Rep No.B18076

Fuji Electric FA Components &
Systems Co., Ltd.

Notification regarding Change in the External Operating Handle, Retainer, Cover Side Shape, and Screw Bag Specification for Molded Case Circuit Breakers and Earth Leakage Circuit Breakers

Details of Retainer Shape Change

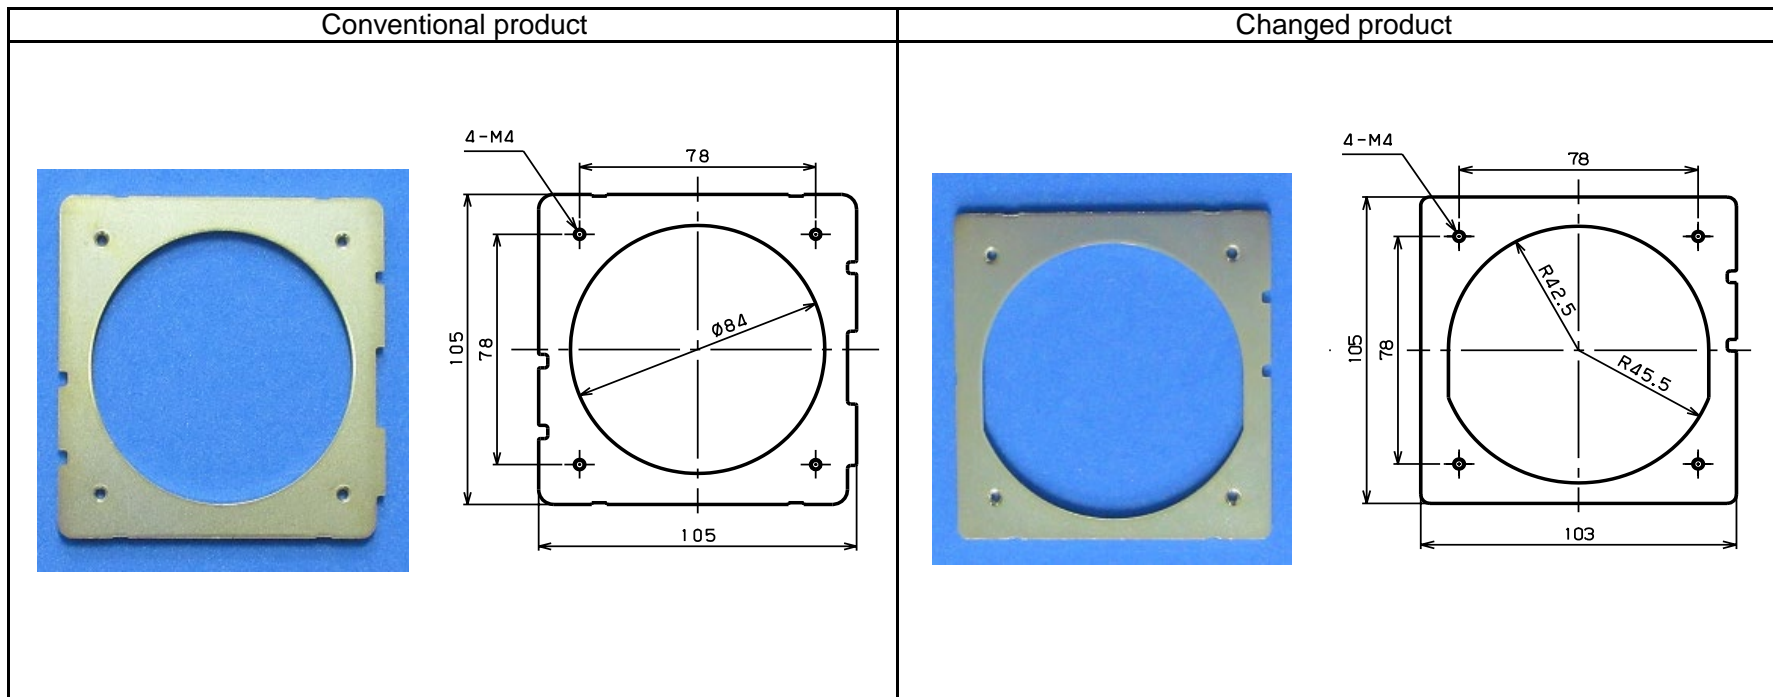
Product name	Molded Case Circuit Breaker/Earth Leakage Circuit Breaker
Series name	V Type External Operating Handles
Types	BZ6V10C, BZ-V20C, BZ-V50C
Changed parts	(1) Retainer, (2) Cover side, (3) Screw bag label
Details of the change	Details of change (1): The outline dimensions of the retainer will be changed. Details of change (2): The shape of the cover side will be changed. (Applicable to BZ6V10C only) Details of change (3): The label specification for the accessory screw bags will be changed. (Applicable to BZ6V10C only) *For details about the change, refer to the attachments.
Reason for change	Details of change (1): To standardize parts. Details of change (2): To improve the external appearance and assembly workability. Details of change (3): To prevent the inclusion of the wrong accessory screws.
Date of the production change	Scheduled for products to be produced from September 2019
Attachment	Attachment 1: "Details of Retainer Shape Change" Attachment 2: "Details of Cover Side Shape Change" Attachment 3: "Screw Bag Label Specification Change"

Attachment 2
Details of Cover Side Shape Change

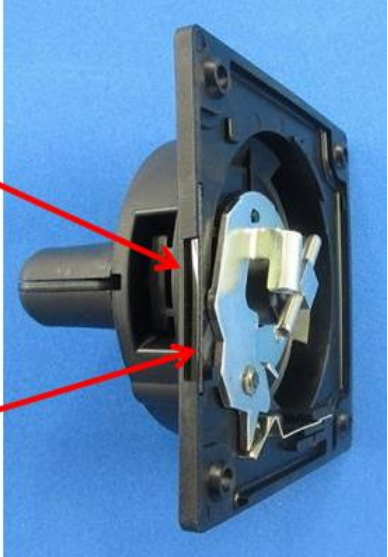
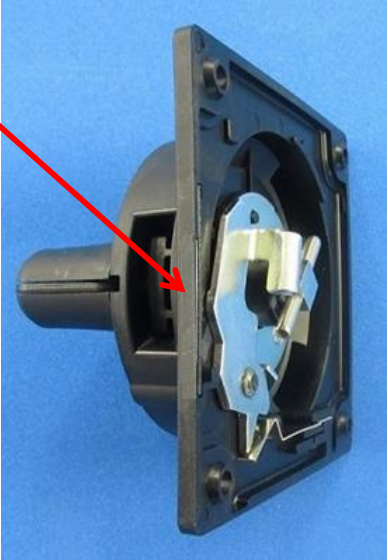
Conventional product	Changed product
<p data-bbox="203 687 439 715">Cover side shape</p> <p data-bbox="203 751 533 778">Cover recess + side wall</p>  <p data-bbox="248 1193 389 1254">Side wall closing part</p>  <p data-bbox="427 863 600 890">Cover recess</p> <p data-bbox="488 1121 607 1149">Side wall</p>	<p data-bbox="1088 679 1323 707">Cover side shape</p> <p data-bbox="1088 743 1458 804">Integral molding of cover to form the outer shell</p>
